Block 20a EDMONDSON PARK AFFORDABLE HOUSING

RESPONSE TO KEY ISSUES

Project Address Lot 401, Lot 402, Cnr MacDonald Rd +
 Buchan Ave, Edmondson Park, NSW 2174
Project Number 2518
Phase State Significant Development Application
Version -
Date Issued 27.07.2026
Prepared by CH
Checked by AA

Version	Amendment	Date
-	Response to DPHI Key issues	27.07.2026

Figure 1
Typical floor plan overlay with red circle highlighting areas where interface conditions of windows and balconies should be reconsidered

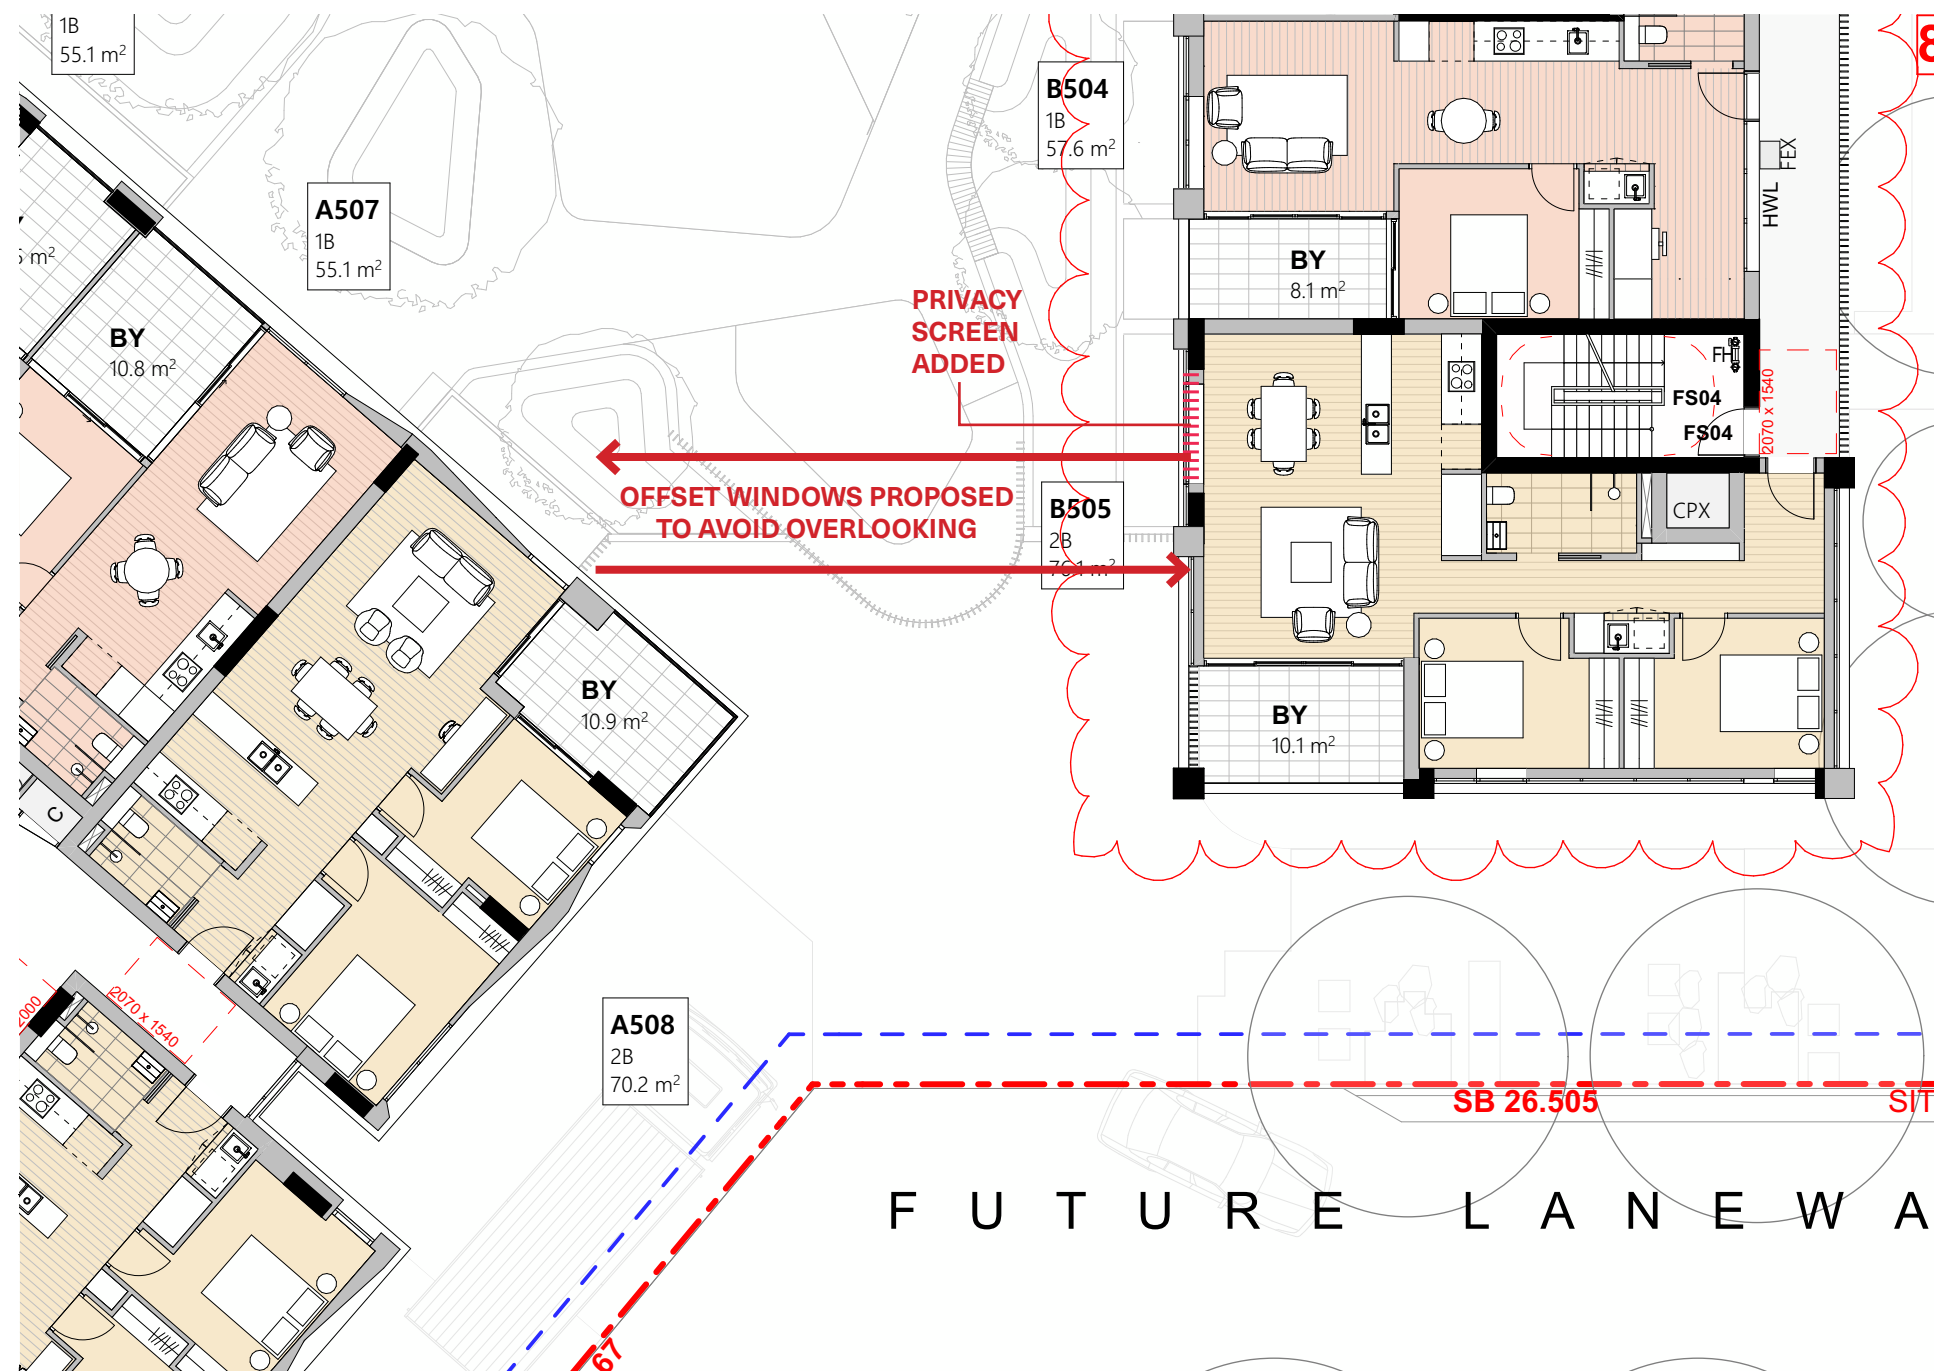
The Department requests that the interface conditions of windows adjoining habitable rooms and balconies between Building A and Building B be reconsidered to increase privacy and amenity or justified having regard to the ADG objectives (see Figure 1 below).

Objective 3F-1 of the Apartment Design Guide (ADG) states that building separation is to achieve reasonable levels of visual privacy and provides minimum separation distances for habitable room windows and balconies.

The proposed separation between levels 2 to 8 at Building A and Building B is 9.3m at the closest point which does not meet the design criteria of part 3F-1. As the buildings are on the same site, a minimum separation of 12m (up to 4 storeys) and 18m (5-8 storeys) is recommended.

The proposed design has provided for offset windows so that the 2 units do not directly overlook each other.

An additional privacy screen is proposed to provide further privacy between the 2 units.

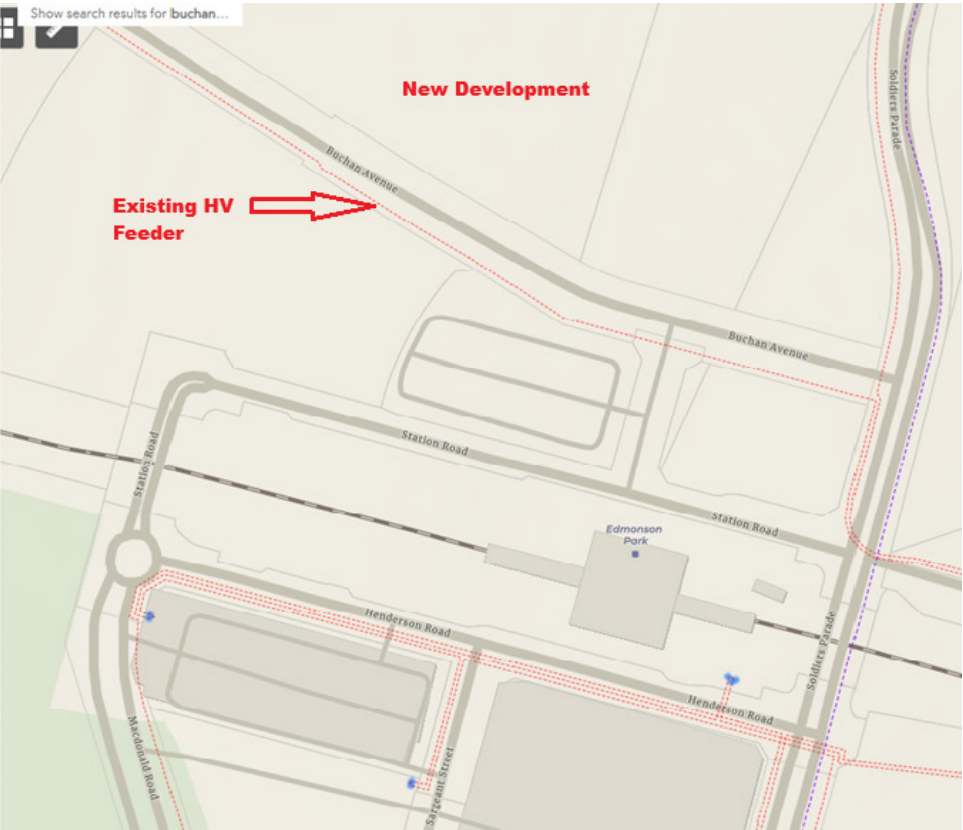
The Department requests that the location of the substation fronting Buchan Avenue be reconsidered. In its current location, the substation adversely impacts residential amenity, reduces the opportunity for planting to the side setback and detracts from the overall presentation of the building in the streetscape.

It is noted that the State Design Review Panel recommended the substation be relocated into the central services area and the Department requests this option be further explored.

A number of options were explored as part of the SSDA process (for a range of locations as well as types that included the mini chamber) to arrive at the proposed solution. Considering the HV network location, EE access requirements, constructability, spatial constraints, and cost implications, a padmount substation located along Buchan Avenue is considered the most suitable solution for this development.

The existing EE high voltage (HV) network is located along Buchan Avenue, directly adjacent to the development frontage. The proposed development substation will connect to this existing HV network. Therefore, locating the substation along Buchan Avenue is considered the most suitable arrangement, as it minimises the HV feeder extension requirements and avoids additional costs associated with extending the HV network towards the future Macdonald Road connection.

In accordance with Endeavour Energy standards, including MCI0006 and MDI0028, substations are required to be located at the front boundary with 24/7 access from a public street. The proposed indoor substation location does not satisfy these requirements, as it does not have direct access from a public road and is offset from the future laneway. This arrangement may create difficulties for the delivery, installation, and future replacement of major equipment, including transformers, due to restricted access for heavy vehicles and lifting equipment. A substation at this location is subject to EE approval and will require a dispensation request to be submitted to EE. The dispensation request will need

to be accompanied by a transformer delivery methodology from an ASP Level 1, and detailed drawings showing the access route and slope. A Right of Way will also need to be established on the property title for EE access the substation.

From a cost and spatial perspective, a padmount substation provides a more practical solution compared with an indoor substation. An indoor substation requires additional structural and architectural provisions, including a dedicated substation room, fire-rated construction, ventilation, and equipment access requirements. Based on a high-level cost estimate, an indoor substation is approximately \$350,000 (excludes building costs) compared with approximately \$200,000 for a padmount substation.

The indicative footprint requirements are also greater for an indoor substation, with a size of 5.7 m × 4.6 m (internal dimension) and 2 hr fire rated walls ceiling and floor, compared with a padmount substation footprint of 5.5 m × 2.75 m (overall site area required). In addition, an indoor substation requires a minimum 1.5 m × 1.5 m hardstand area at the frontage to facilitate equipment delivery and unloading.

As part of the landscape design, the area around the substation will be screened with planting and the kiosk itself will become an opportunity for public art that speaks to Country. This will be investigated during the Detailed Design stage.

SUBSTATION OPTIONS EXPLORED

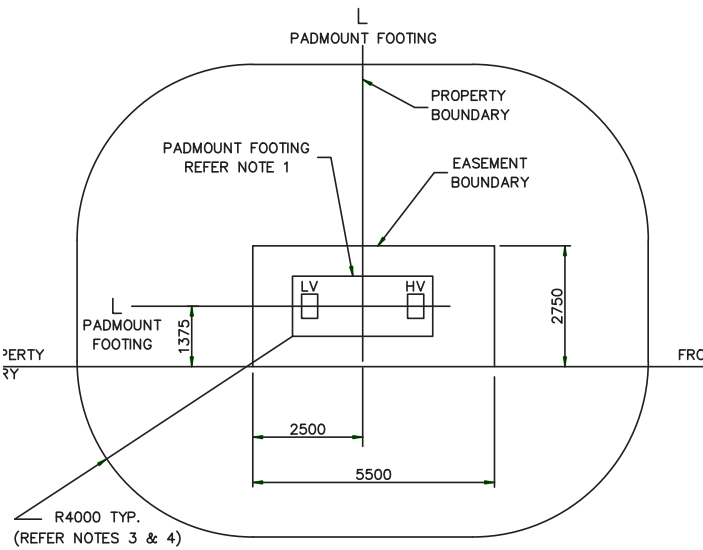
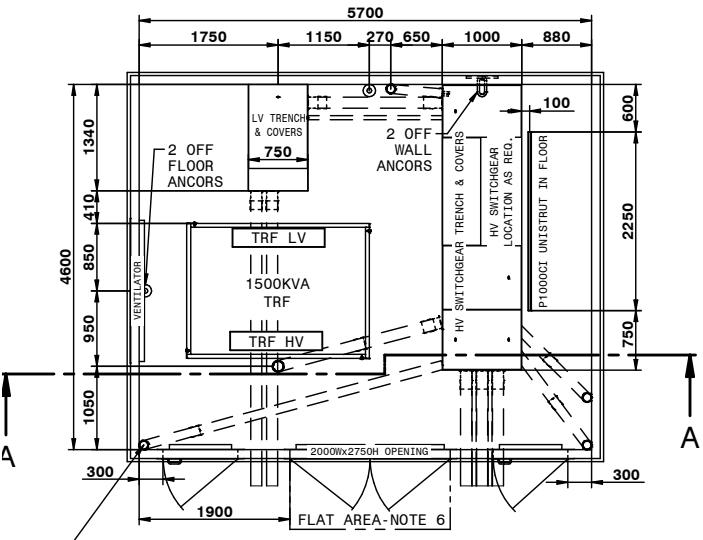
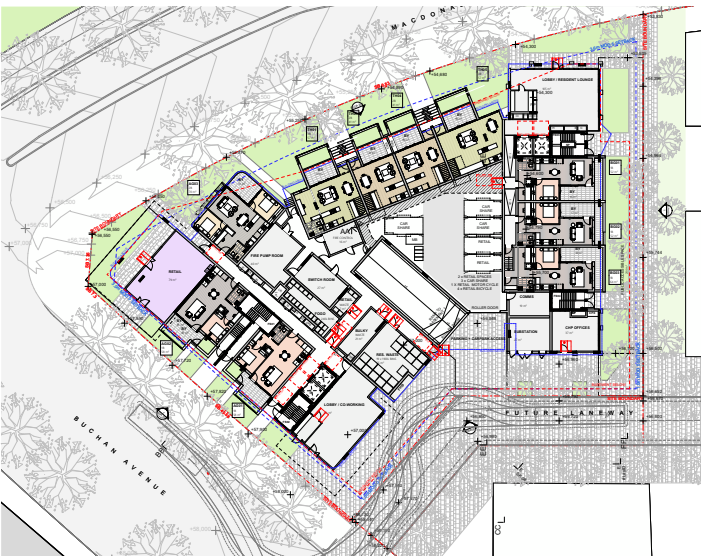
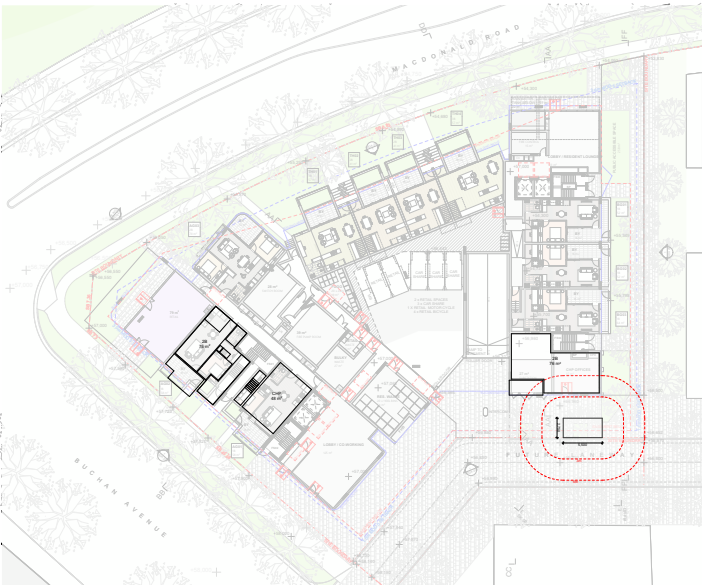
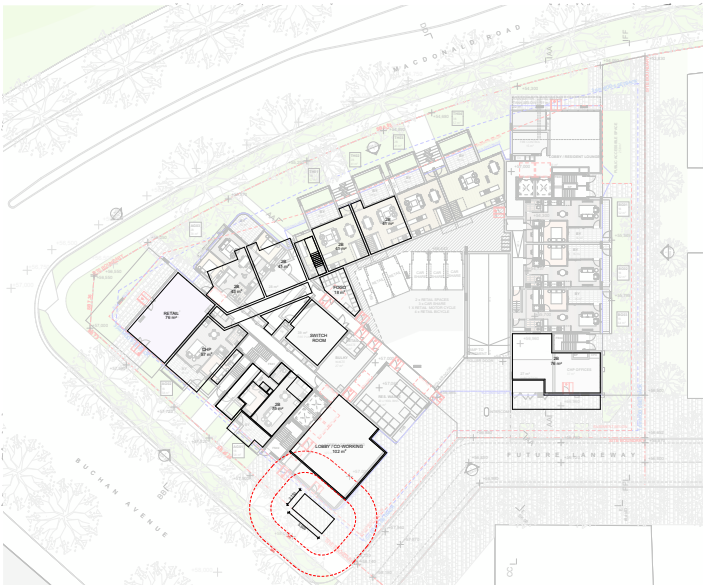
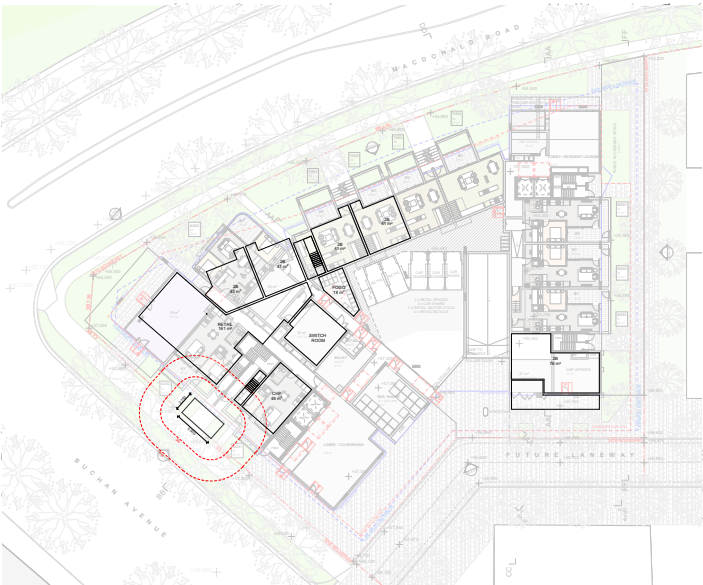
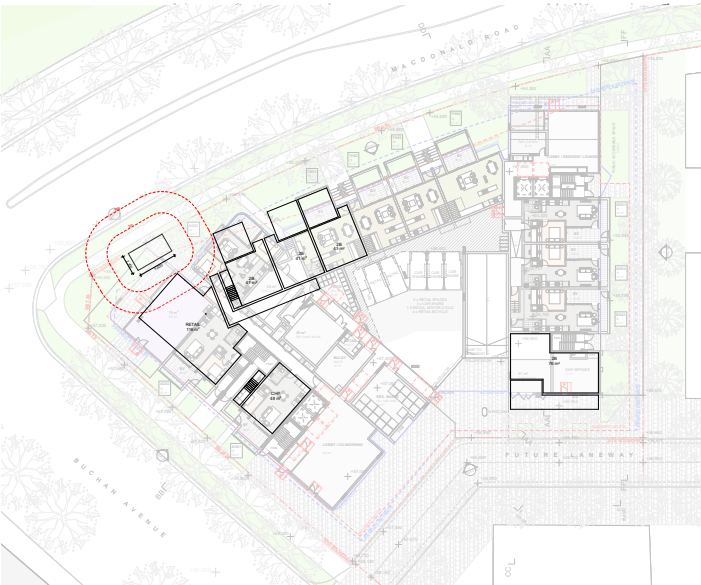
- Increased inactive frontages along laneway
- Additional costs required to extend the HV network
- Location does not have direct access from a public road and is offset from the future laneway making delivery, installation, and future replacement an issue
- Bigger footprint required compared to a padmount.

- Maximises active frontages to laneway
- Location on key corner approach not ideal for services
- Additional costs required to extend the HV network
- Location does not have direct access from a public road and is offset from the future laneway making delivery, installation, and future replacement an issue

- Maximises active frontages to laneway
- Location on key corner approach not ideal for services
- Additional costs required to extend the HV network

- Located away from key corners
- Maximises active frontages to laneway
- Connects to existing HV network, minimises HV feeder extension requirements and avoids additional costs associated with extending the HV network

- Maximises active frontages to laneway
- Location on key corner approach not ideal for services
- Additional costs required to extend the HV network

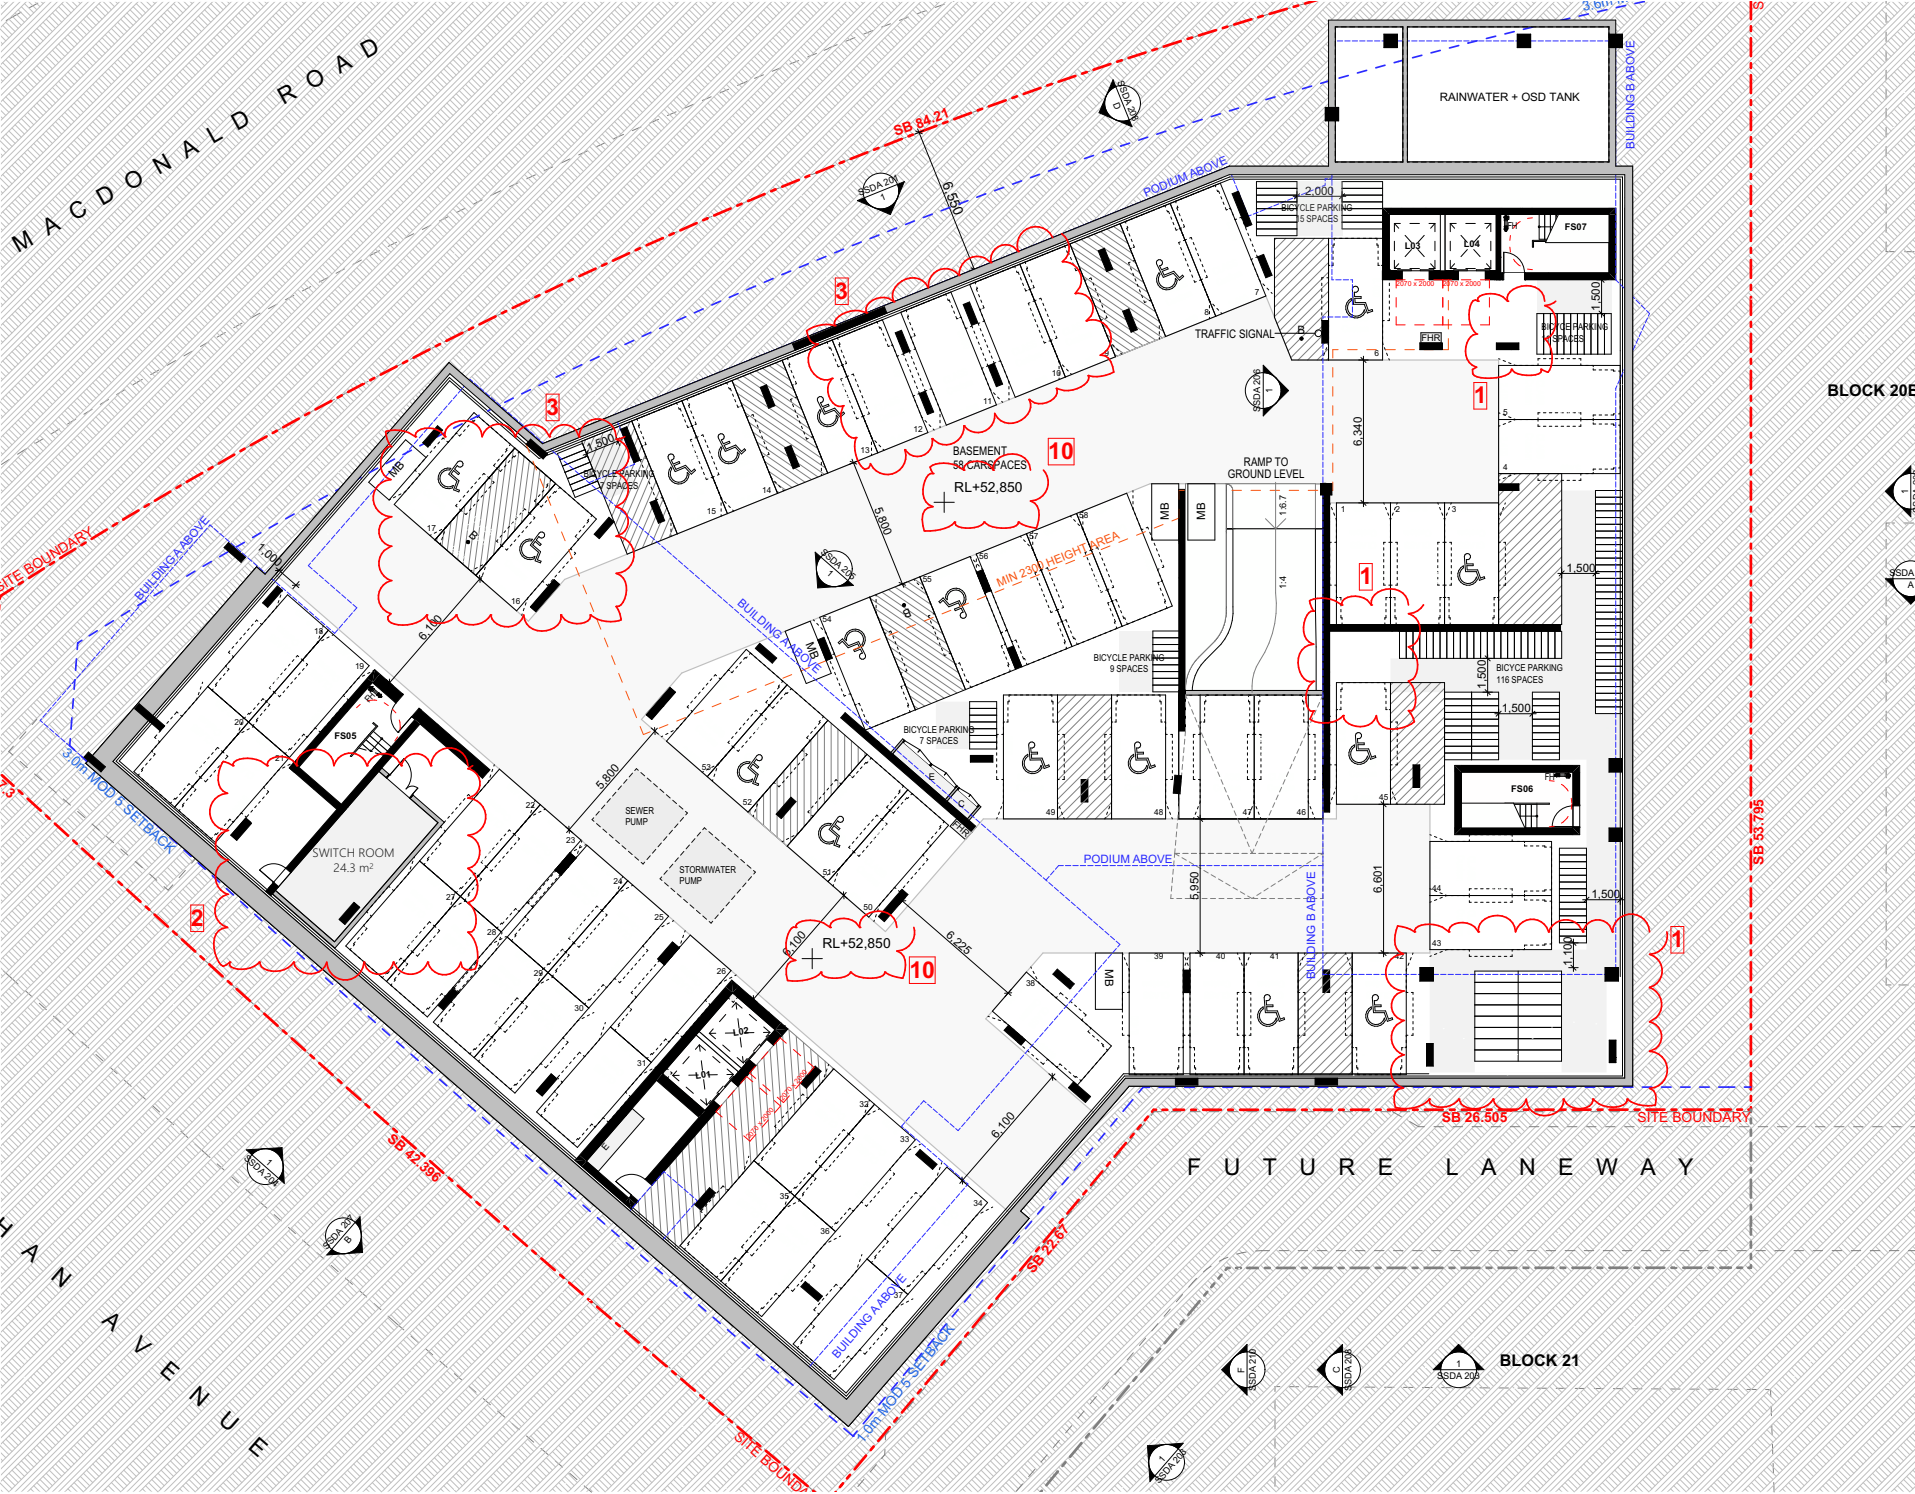
Basement 01 Plan shows car parking spaces including 38, 54, and 58 overlapping with adjoining spaces or walls. The Department requests that you confirm all car parking spaces comply with the required minimum dimensions and do not intersect with other components in the basement.

Updated plans are provided confirming all car parking spaces comply with the required minimum dimensions and do not intersect with other components in the basement.
